TRANS/WP.29/2004/17  
2 December 2003

World Forum for Harmonization of Vehicle Regulations (WP.29)  
(One-hundred-and-thirty-second session,  
9-12 March 2004, agenda item 4.2.16.)

PROPOSAL FOR SUPPLEMENT 3 TO REGULATION No.106

(Agricultural tyres)

Annex 10, the table, insert two new rows to read:

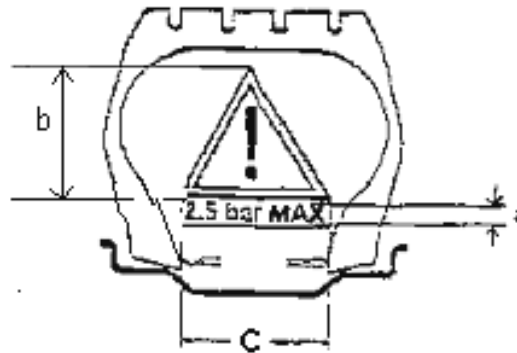
Classification code	Nomenclature
.....	.....
I-6	Agricultural implement tyres : Smooth tread
LS-1	Logging and Forestry Service Tyres : regular tread
LS-2	.....
LS-3	.....
LS-4	Logging and Forestry Service Tyres : shallow tread
.....	.....
